**2021 CMOM Package 7
Solicitation Number: CO-00685
Job No.: 22-4516**

**ADDENDUM 2
October 24, 2023**

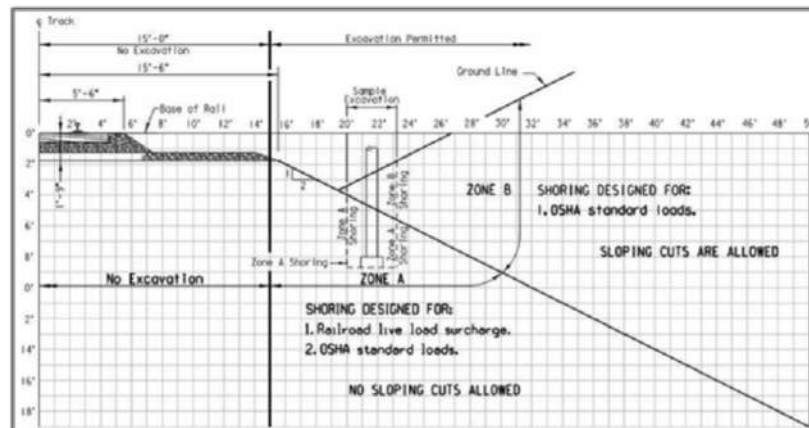
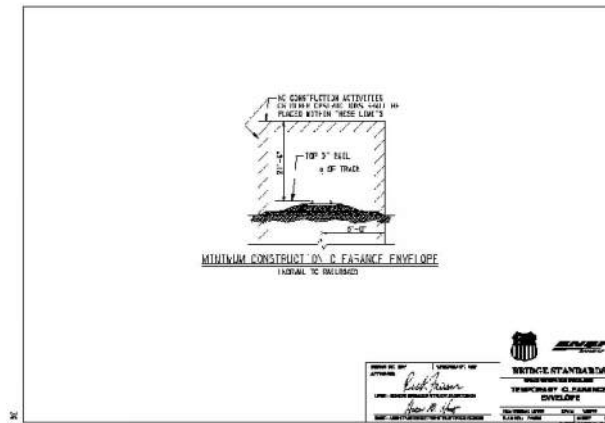
1. Remove the following sheets dated 09/26/23 and 9/29/23 in their entirety and replace with the attached sheets dated 10/20/2023:
- a. Sheet 005 GENERAL NOTES (Sheet 3 of 3)
 - Modified to remove UPRR track and ground monitoring requirements.
 - b. Sheet 006 OVERALL QUANTITIES
 - Modified to reflect removal of line item 130.
 - c. Sheet 008 SITE 1 CMPKY 973775, 973902 STA 10+00 - 16+11 CIPP REHAB
 - A note identifying the 100-year flood elevation has been added.

2021 CMOM PKG 7
SITE 2 CMPKY 3466470
STA 10+00 - 10+98 CIPP
RHB & PNT RPR

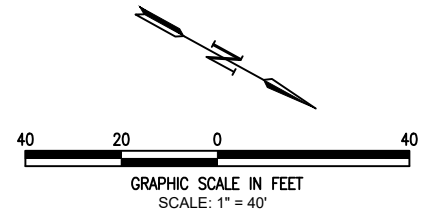
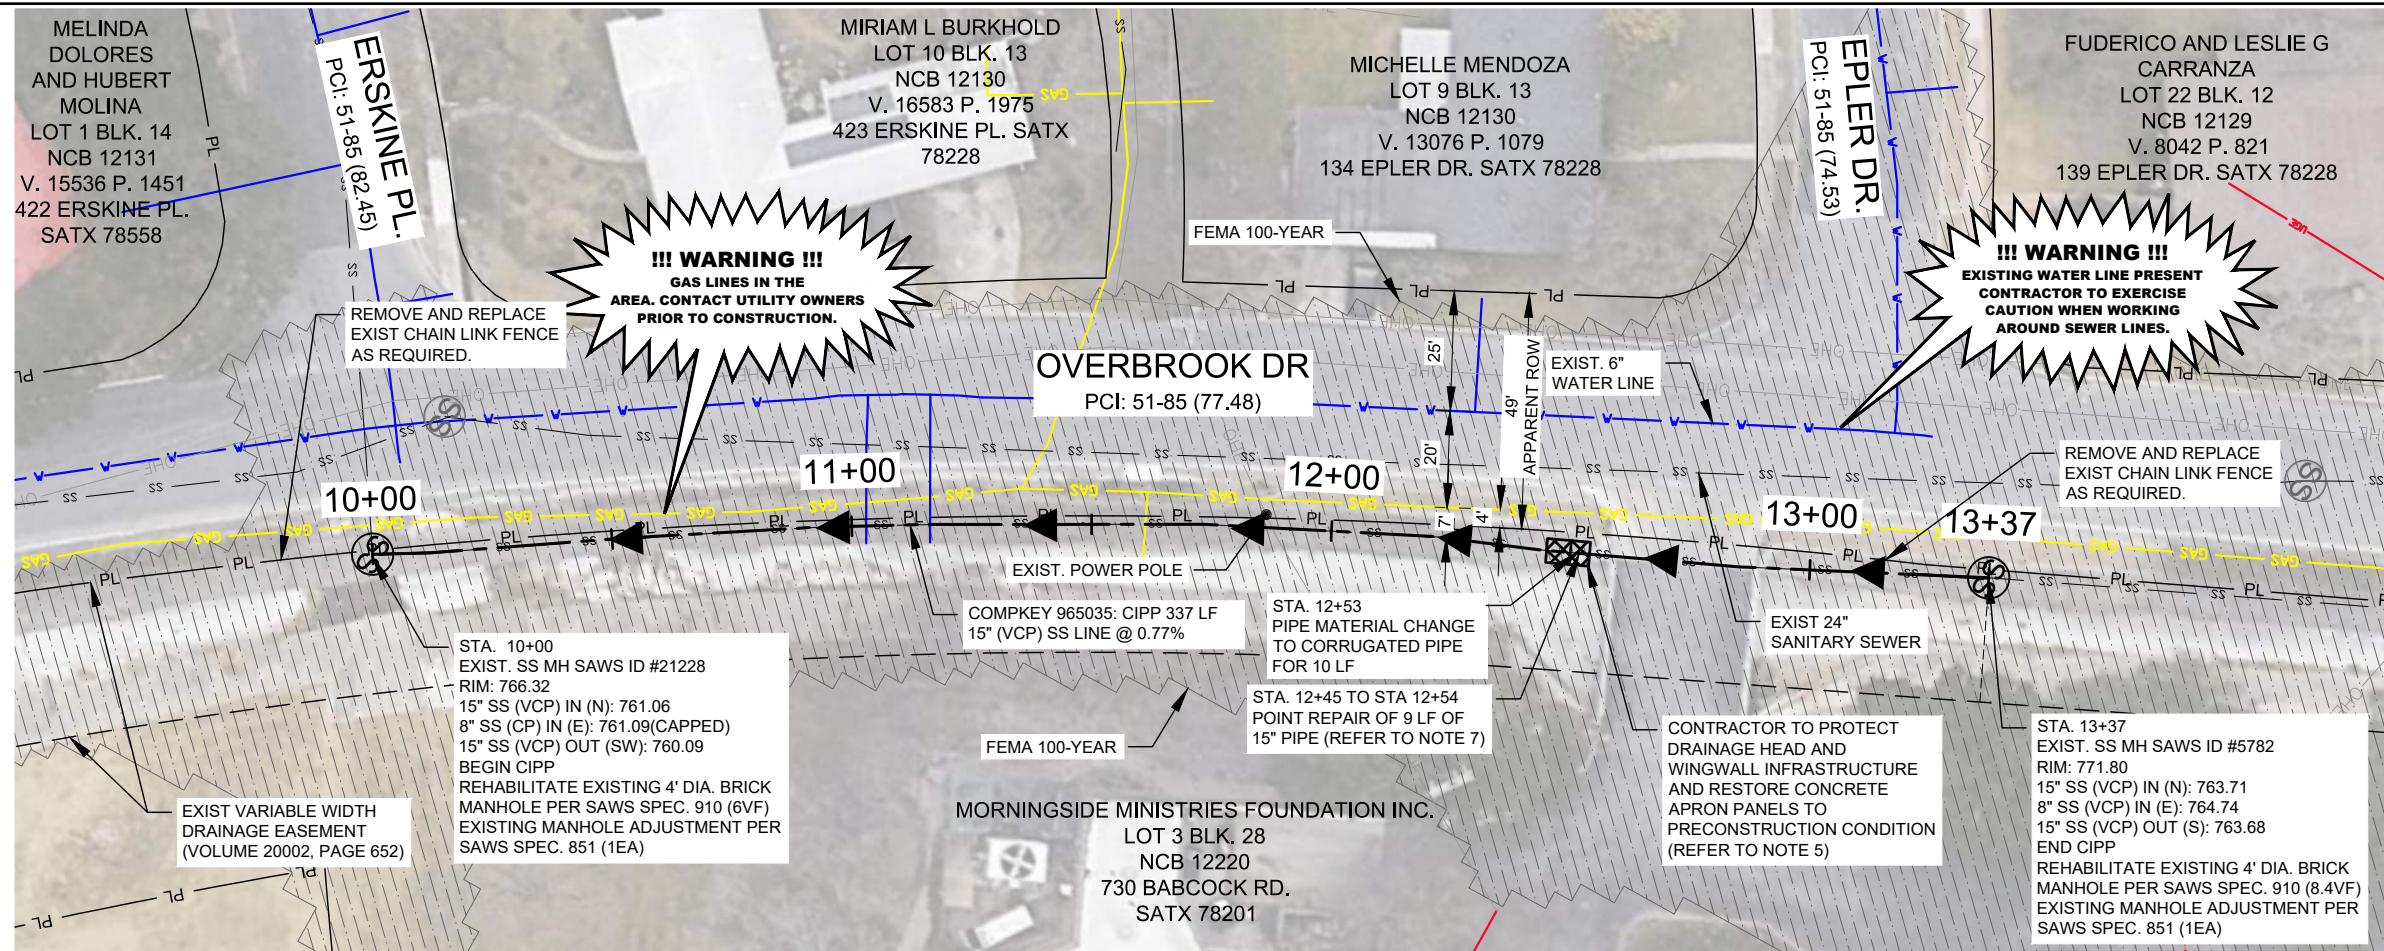
- d. Sheet 011 SITE 2 CMPKY 3466470 STA 10+00 - 10+98 CIPP RHB & PNT RPR
 - A note identifying the 100-year flood elevation has been added.
- e. Sheet 017 SITE 4 CMPKY 965035 STA 10+00 - 13+37 CIPP RHB & PNT RPR

- CONTRACTOR TO COORDINATE AND NOTIFY VIA REGARDING BUS ROUTES. REFER TO VIA NOTES ON SHEET 4.
- COSA FLOODPLAIN DEVELOPMENT PERMIT (FPDP) IS REQUIRED AT THIS SITE. SAWS TO OBTAIN FPDP.
- CCTV SHOWS AN EXISTING AT&T COMMUNICATION LINE DRILLED INTO THE SEWER PIPE AT THE POINT REPAIR 87 TO 96 LF FROM MH #966565. CONTRACTOR TO COORDINATE WITH AT&T FOR A UTILITY REPRESENTATIVE ONSITE WHEN MAKING THE REPAIR AND ADJUSTING THE COMMUNICATION LINE OUTSIDE OF SAWS INFRASTRUCTURE.
- THE 100-YEAR FLOOD PLAIN ELEVATION IS 763.00 FEET.

REVISIONS
 2021 CMOM PKG 7
SITE 4 CMPKY 965035 STA 10+00 - 13+37 CIPP RHB & PNT RPR

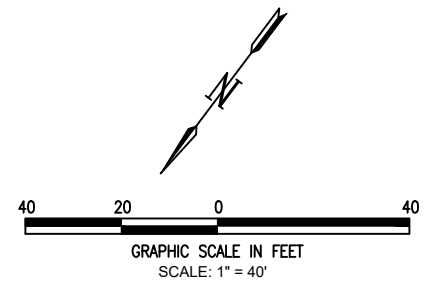
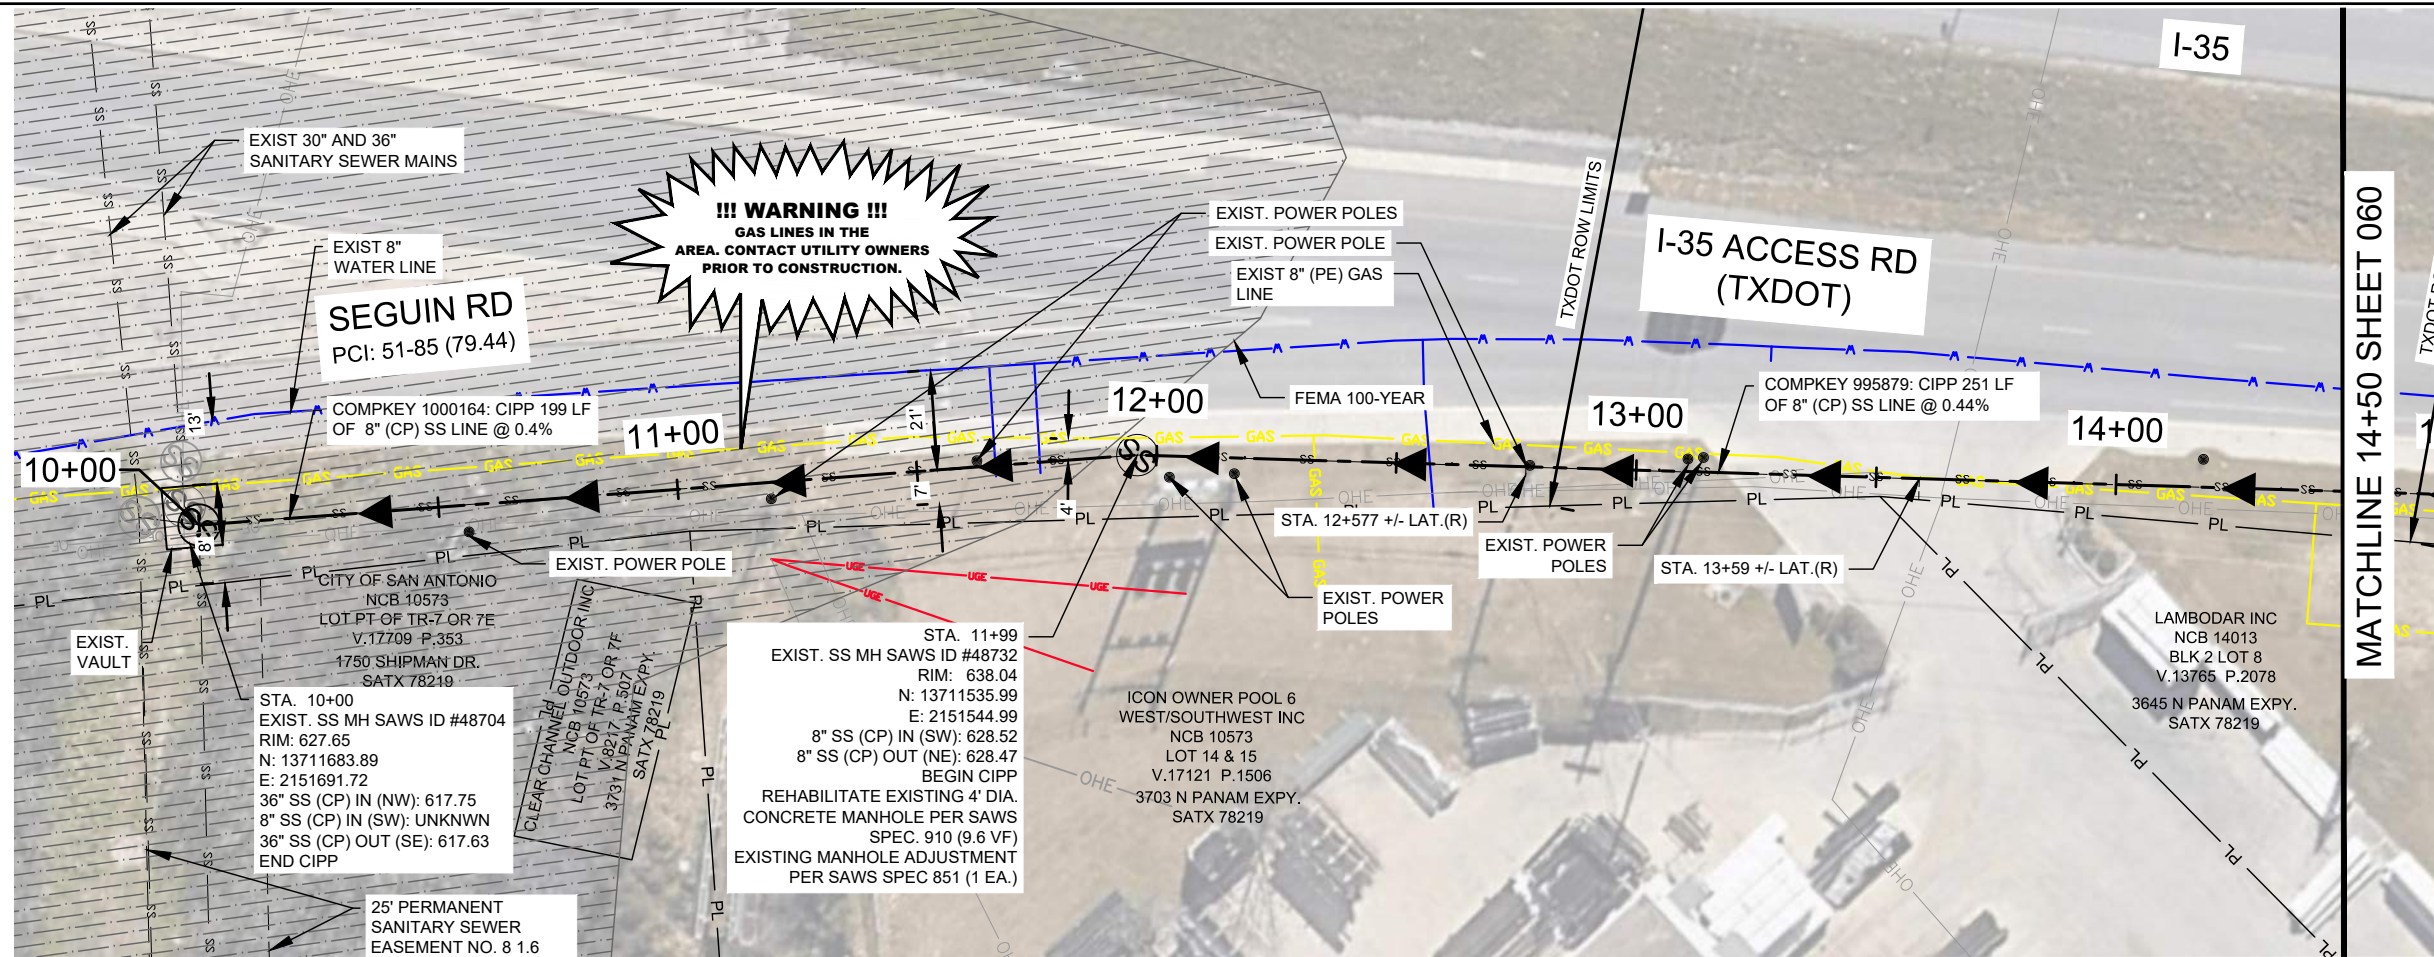
- A note identifying the 100-year flood elevation has been added.
- f. Sheet 059 SITE 16 CMPKY 995879, 1000164 STA 10+00 - 14+50 CIPP RHB
 - A note identifying the 100-year flood elevation has been added.

REVISIONS
 2021 CMOM PKG 7
SITE 17 CMPKY 975245
STA 10+00 - 13+68 CIPP
RHB

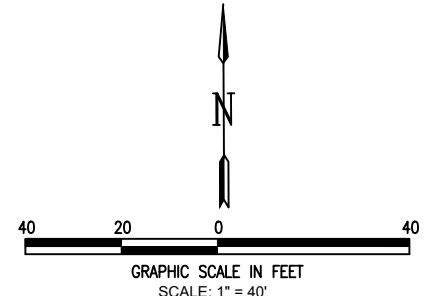
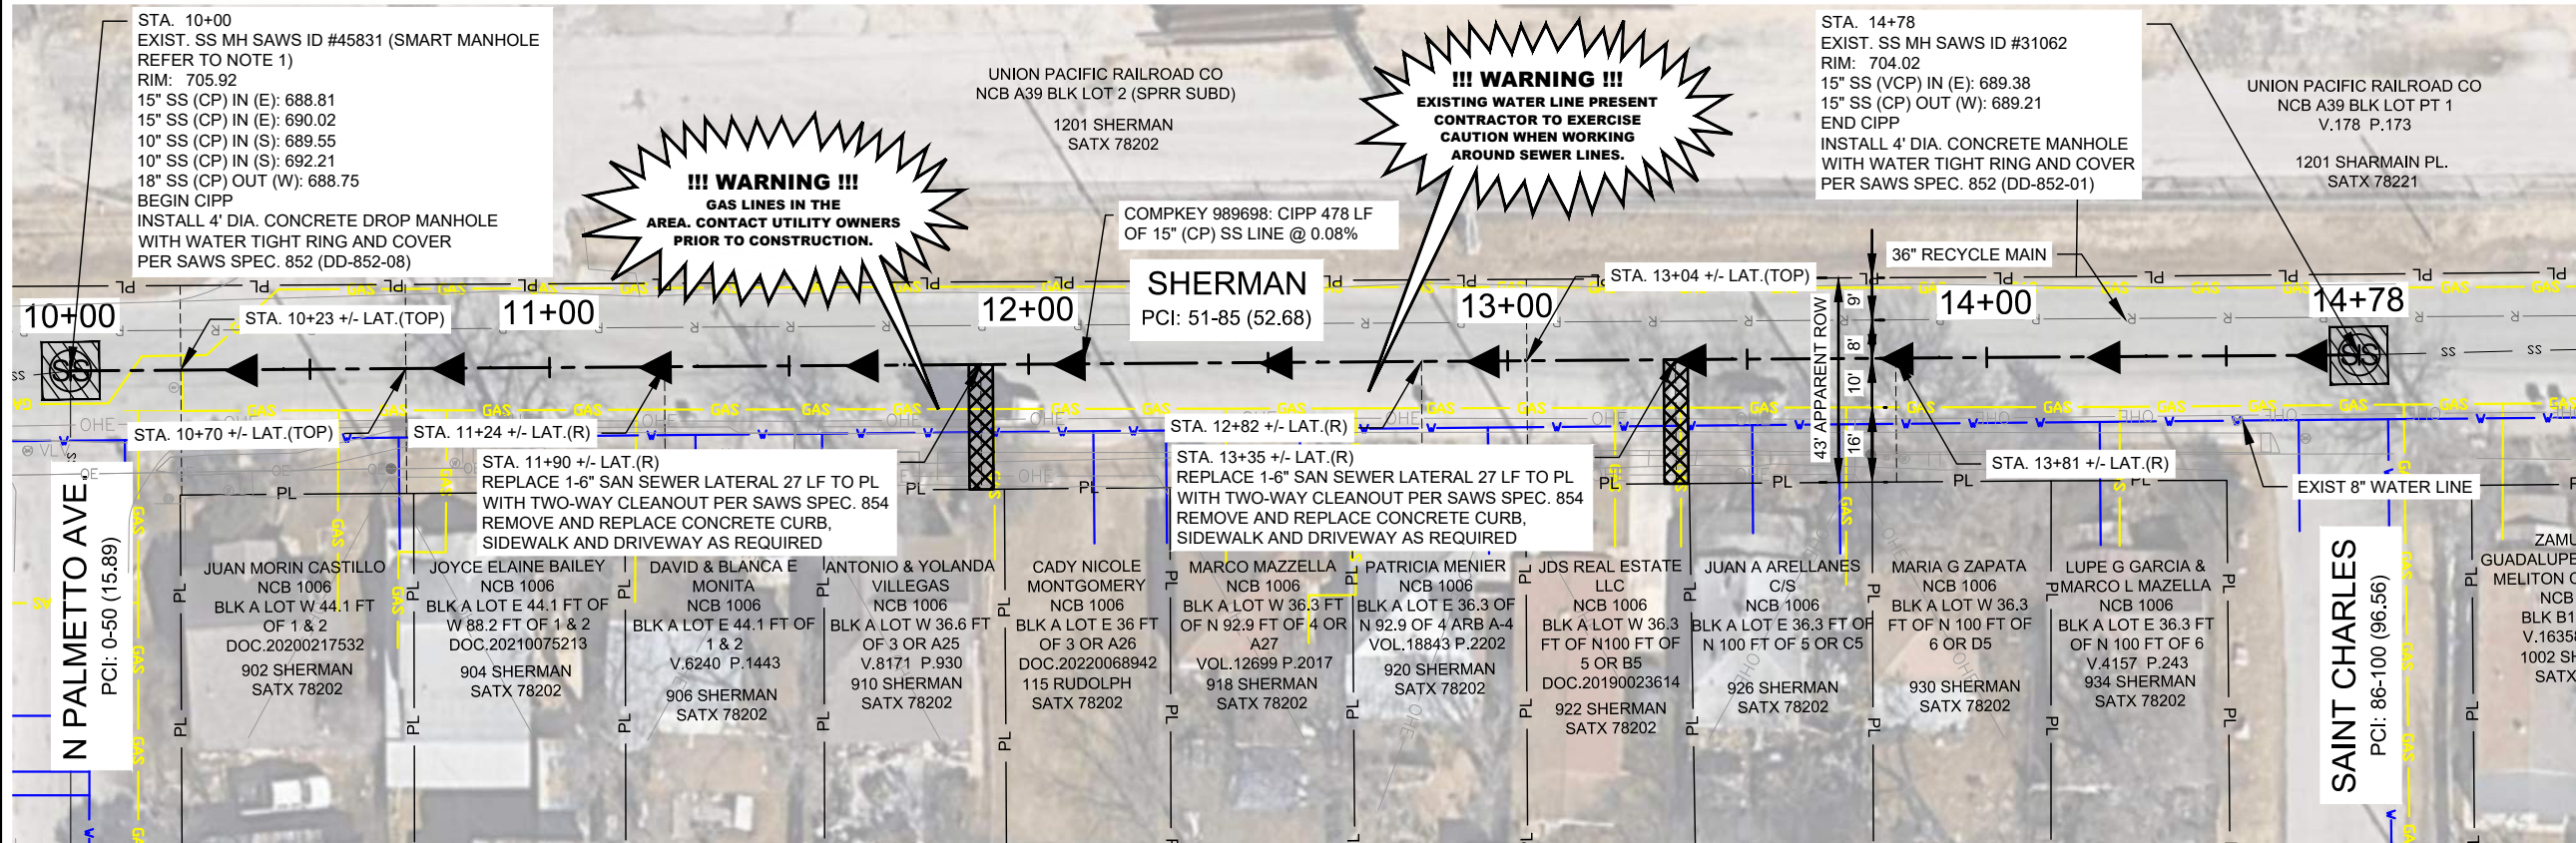
- g. Sheet 063 SITE 17 CMPKY 975245 STA 10+00 - 13+68 CIPP RHB
 - A note identifying the 100-year flood elevation has been added.
- h. Sheet 079 SITE 22 CMPKY 989698 STA 10+00 - 14+78 CIPP RHB

- THIS SITE REQUIRES A COSA FLOODPLAIN DEVELOPMENT PERMIT.
- CONTRACTOR TO COORDINATE AND NOTIFY VIA REGARDING BUS ROUTES. REFER TO VIA NOTES ON SHEET 4.
- ZARZAMORA PEDESTRIAN IMPROVEMENTS PROJECT (SW MILITARY TO FRED) IS SCHEDULED TO BE UNDER CONSTRUCTION FROM (OCT 2023 - AUG 2024). CONTRACTOR TO COORDINATE WITH COSA ABOUT WHEN ROW PERMIT FOR THIS SITE CAN BE ISSUED.
- THE 100-YEAR FLOOD PLAIN ELEVATION IS 664.00 FEET.

MAP No. 000-000 SHEET 079
 SECT. No. _____
 DR: UOP CK: MML JOB No. 22-4516 OF 145

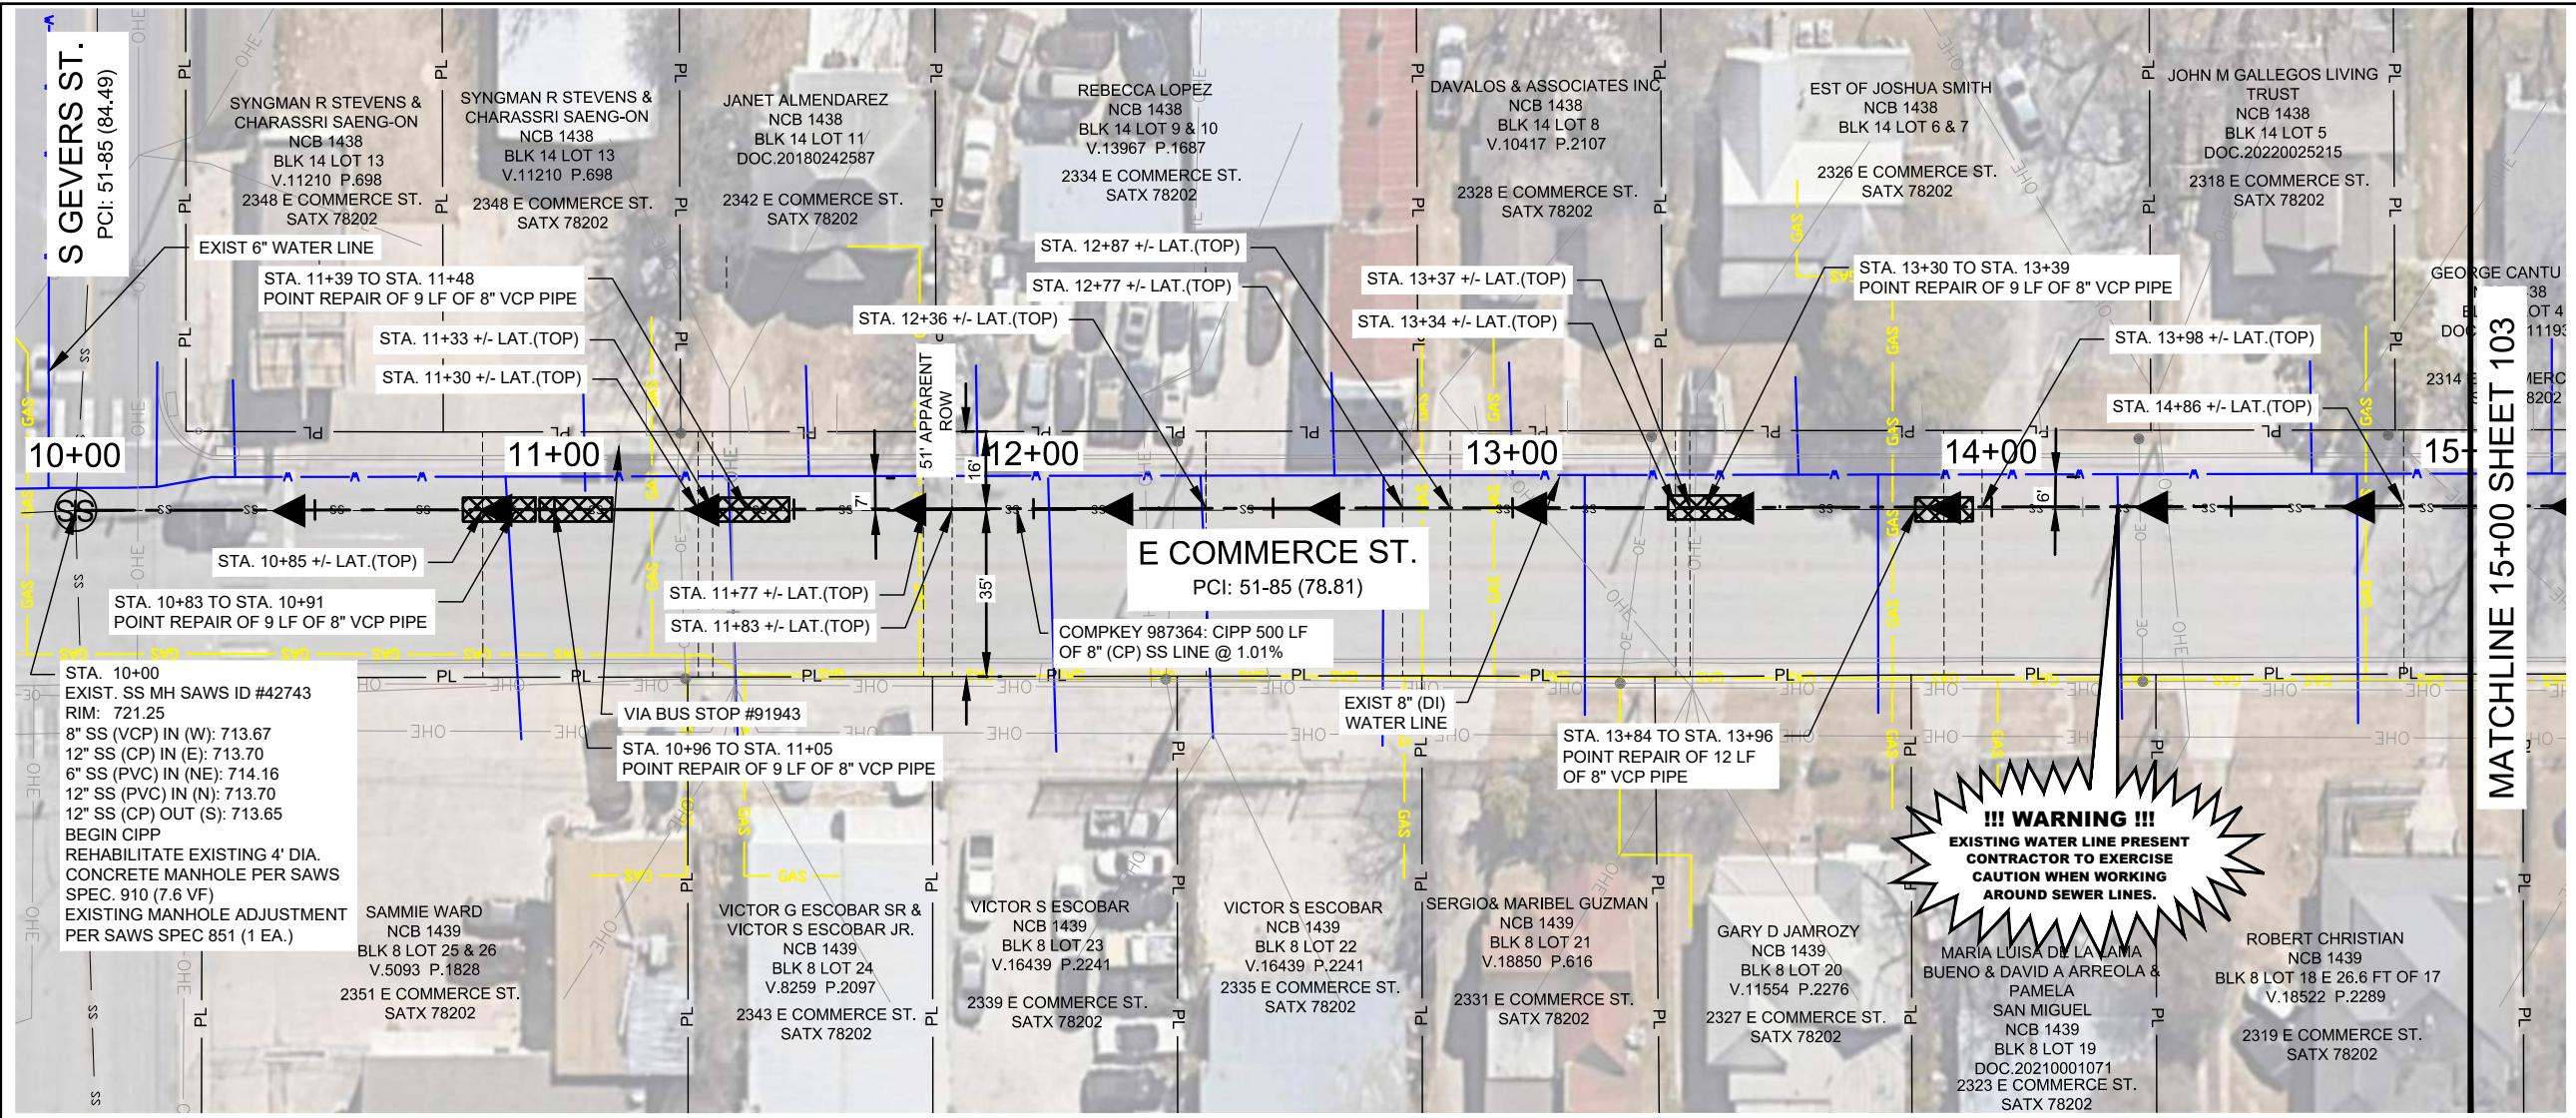
- The note "SAWS IS IN THE PROCESS OF OBTAINING A PHASE II ESA REPORT FOR THIS SITE. REFER TO CONTRACT DOCUMENTS SC10" was removed.
 - The note "CONTRACTOR TO REFER TO PHASE II ESA REPORT PROVIDED BY SAWS. SOILS GENERATED BY EXCAVATION DOWN TO 5 FEET BELOW REMOVED PAVEMENTS ARE TO BE REUSED BENEFICIALLY ON SITE OR TREATED AND APPROPRIATELY DISPOSED OF AS NON-HAZARDOUS WASTE (NSPI)" was added.

1. SMART MANHOLE COVERS - REFER TO SEWER NOTE #28 ON GENERAL NOTES SHEET (2 OF 3)
2. CONTRACTOR TO REFER TO PHASE II ESA REPORT PROVIDED BY SAWS. SOILS GENERATED BY EXCAVATION DOWN TO 5 FEET BELOW REMOVED PAVEMENTS ARE TO BE REUSED BENEFICIALLY ON SITE OR TREATED AND APPROPRIATELY DISPOSED OF AS NON-HAZARDOUS WASTE (NSPI).
